# EMERGENCY AIRWORTHINESS DIRECTIVE

**Number: G-2021-0014R1-E**

## Hot Air Balloons – Fuel – Cylinder Quick Shut-off Valve Mounting Flange – Inspection / Replacement

Figure 1: *CB437 Flanged Adaptors for Quick Shut-Off (QSO) valves*

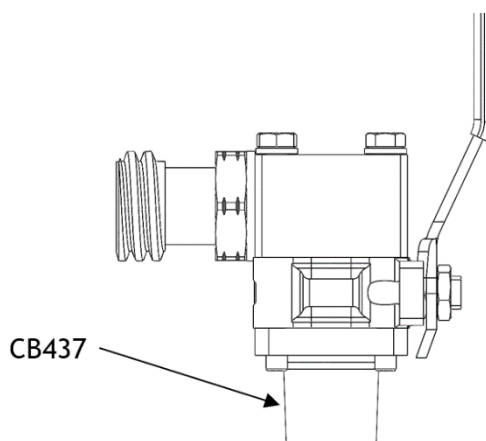
Certain Cameron Hot Air Balloon fuel cylinders are supplied with liquid offtakes that consist of a quarter turn ball valve mounted on a flanged adaptor (P/N CB437, see figure 1). Two recent batches of these adaptors have been manufactured with non-conforming (undersize) threads.

In certain cases, when the minimum sized adaptors are combined with cylinder bosses at maximum tolerance dimension and assembled to fuel cylinders, the thread can impinge ("bottom out") on the cylinder boss. Although the required tightening torque value can be achieved at installation, the torque required to unscrew the flange could be below the minimum value. In extreme cases the adaptor may be unscrewed by hand.

4. From the 04 October 2021 (the effective date of AD G -2021-0010-E), do not install an affected part on any cylinder.
5. Within 4 months after 04 October 2021 (the effective date of AD G-2021-0010-E), modify each cylinder by replacing the P/N CB437 issue F QSO flanged Adaptor, with a P/N CB437 issue H (or later issue) QSO flanged adaptor in accordance with the instructions of the SB, or by replacing the QSO valve assembly with a handwheel valve part No CB0824-0001 (this part has a Rego-type hose connection).
